Access Compliance Report

Public Rights-of-Way (Curb Ramps)

Intersection ID: 30454	Main Street: SHALOM_PARK_DR	Cross Street: PROVIDENCE_RD	Location: SE
ADA ID: 6CE6A5E106AE	Ramp Type: BlendTrans2	Initial Pass/Fail: Pass	Overall Compliance: No
		Severity Score: 0

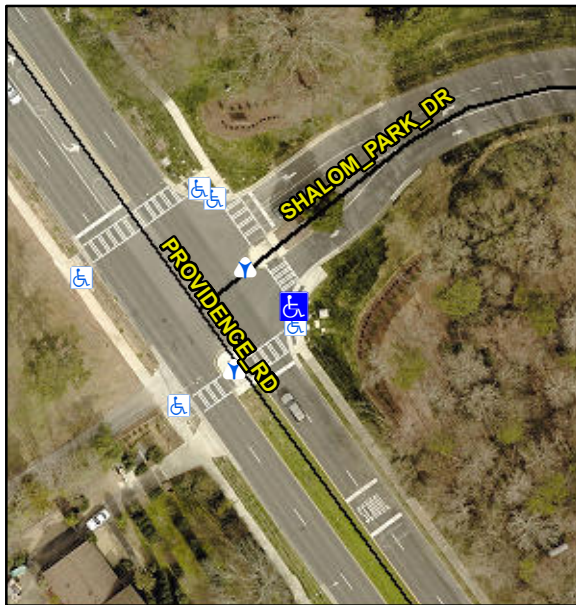
Compliance	Description	Data	Compliance	Description	Data
N/A	Ramp Length (in)	71.0	Yes	BlendTrans Slope (%)	0.6
Yes	Ramp Width (in)	60.0	Yes	BlendTrans XSlope (%)	0.5
N/A	Flare Type LT	N/A	N/A	Flare Type RT	N/A
N/A	Flare Slope LT (%)	N/A	N/A	Flare Slope RT (%)	N/A
N/A	Flare Traversable LT?	N/A	N/A	Flare Traversable RT?	N/A
N/A	Landing Length (in)	N/A	Yes	DWS Provided?	Yes
N/A	Landing Width (in)	N/A	Yes	DWS Contrast?	Yes
N/A	Landing Slope (%)	N/A	Yes	DWS Length (in)	24.0
N/A	Landing X Slope (%)	N/A	Yes	DWS Full Width?	Yes
N/A	Landing Curb? (Y/N)	Yes	No	DWS Offset (in)	3.0
N/A	Shared Landing?	No			
Yes	Gutter Ponding?	No	Yes	Gutter Slope (%)	3.0
Yes	Gutter Lip Ht (in)	0.0	Yes	Gutter X Slope (%)	1.8
N/A	Painted X Walk1?	Yes	N/A	Painted X Walk2?	N/A
	X Walk 1 Direction	To NW		X Walk 2 Direction	N/A
	X Walk 1 Width (in)	112.0		X Walk 2 Width (in)	N/A
	X Walk 1 Slope (%)	0.9		X Walk 2 Slope (%)	N/A
	X Walk 1 X Slope (%)	0.4		X Walk 2 X Slope (%)	N/A

Yes	Ramp inside XWalk1?	Yes	N/A	Ramp inside XWalk2?	N/A
	Road Slope (%)	0.4		Clear Space?	Yes
	Road X Slope (%)	0.9	N/A	Clear Space to XWalk (in)	N/A
Yes	Any Obstructions?	No	Yes	Storm Grate/Utility Hazard?	No
	Obstruction Type			Storm Grate/Utility Type	
		N/A			N/A
			Yes	Surface Condition? (G/P)	Good
			Yes	Curb Slope (%)	1.1

Possible Solutions:

**Remove & Replace Detectable
Warning System.**

R305.2
